HISTORIC AND DESIGN REVIEW COMMISSION

HDRC CASE NO: 2022-373
COMMON NAME: 1111 & 1115 N PALMETTO
LEGAL DESCRIPTION: NCB 1302 BLK 3 LOT E 144.84 FT OF 10
ZONING: R-5, H
CITY COUNCIL DIST.: 2
DISTRICT: Dignowity Hill Historic District
APPLICANT: James Benfield
OWNER: James Benfield
TYPE OF WORK: Amendment to a previously approved design regarding window materials, siding profile and appearance, and fenestration profiles
APPLICATION RECEIVED: May 31, 2022
60-DAY REVIEW: Not applicable due to City Council Emergency Orders
CASE MANAGER: Edward Hall

REQUEST:

a design for
Spec #2
 1111 N. Palmetto

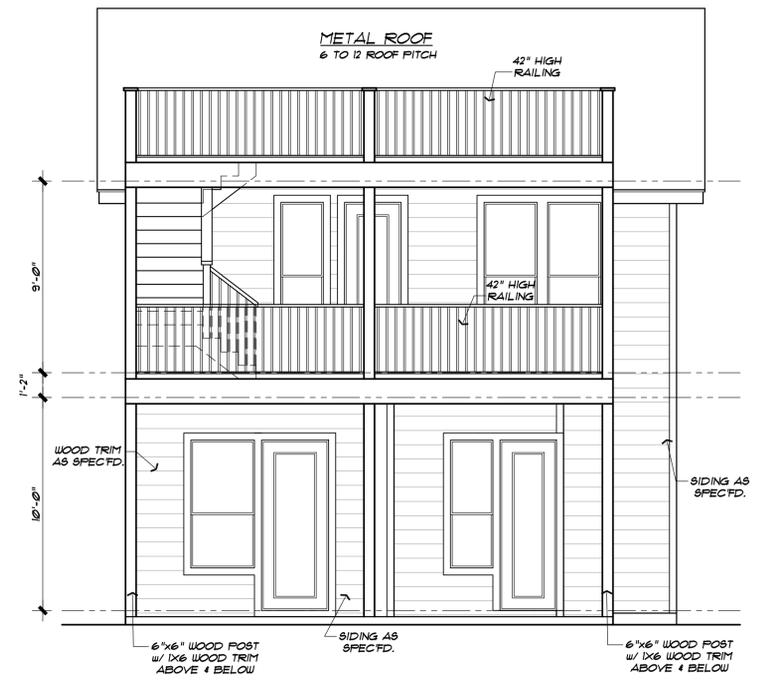
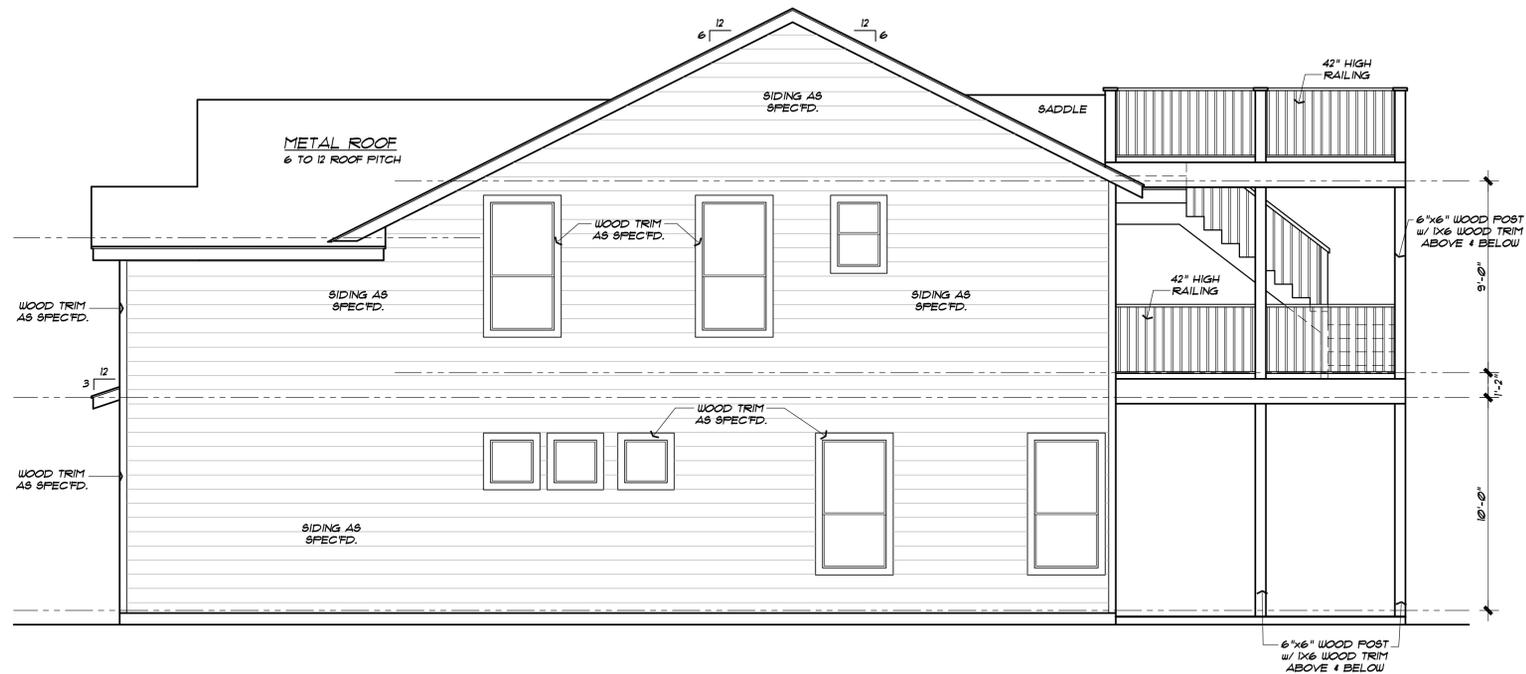
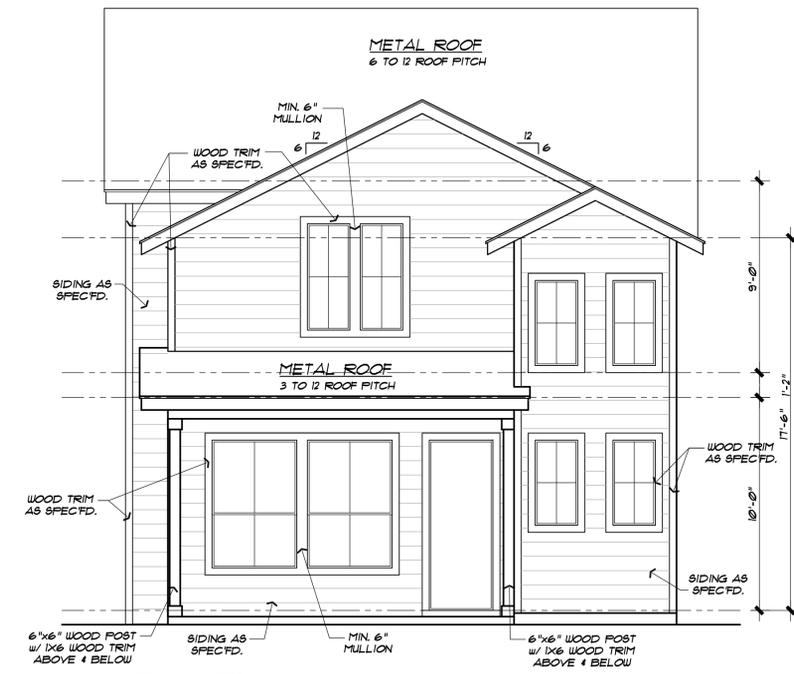
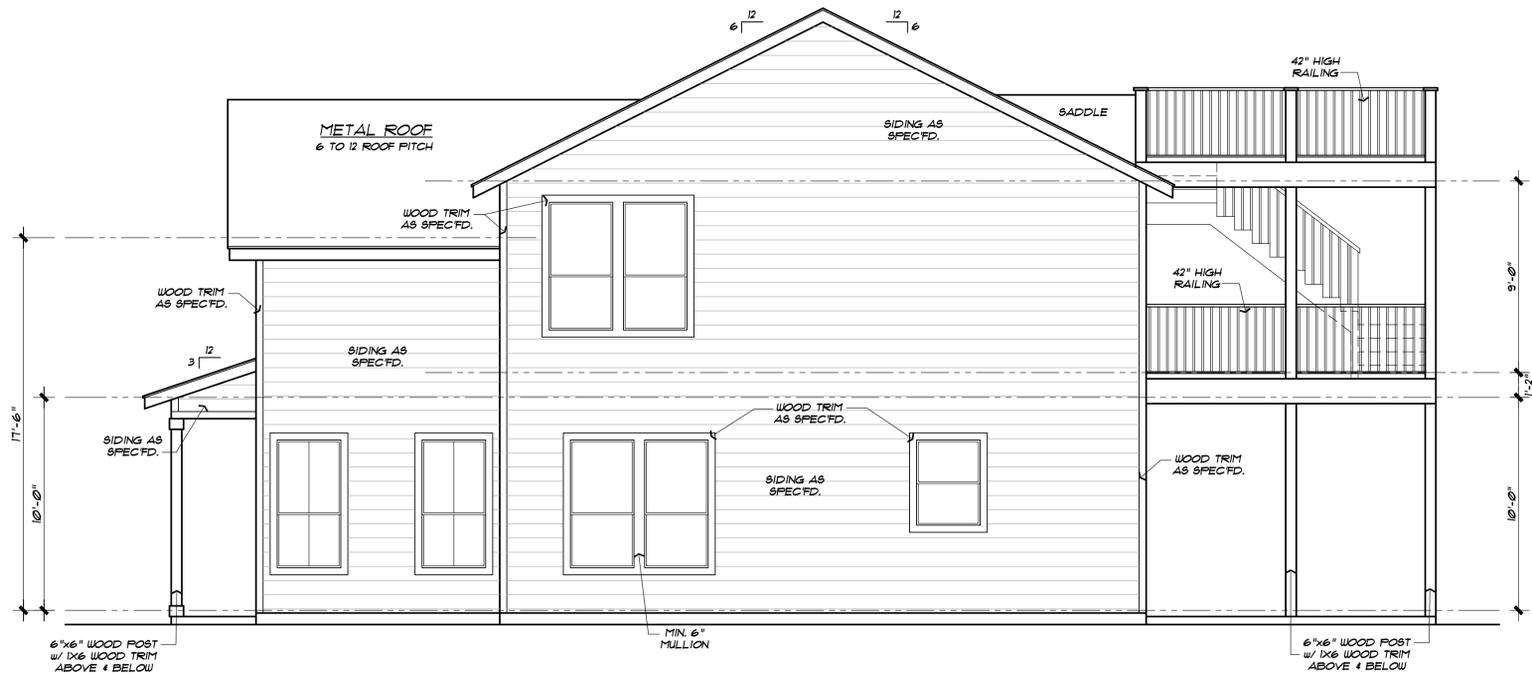
- f. FENESTRATION & DESIGN – The applicant has proposed to amend the previously approved design by modifying the previously approved fenestration pattern for both structures on the north, south and east facades. These modifications include modified window locations and modified windows sizes. Staff finds that the original design should be adhered to, as shown in the original construction documents, as it relates to all fenestration.

2. Staff does not recommend approval of item #2, modifications to existing fenestration and design based on finding d. Staff recommends that the original design should be adhered to, as shown in the original construction documents, as it relates to all fenestration.
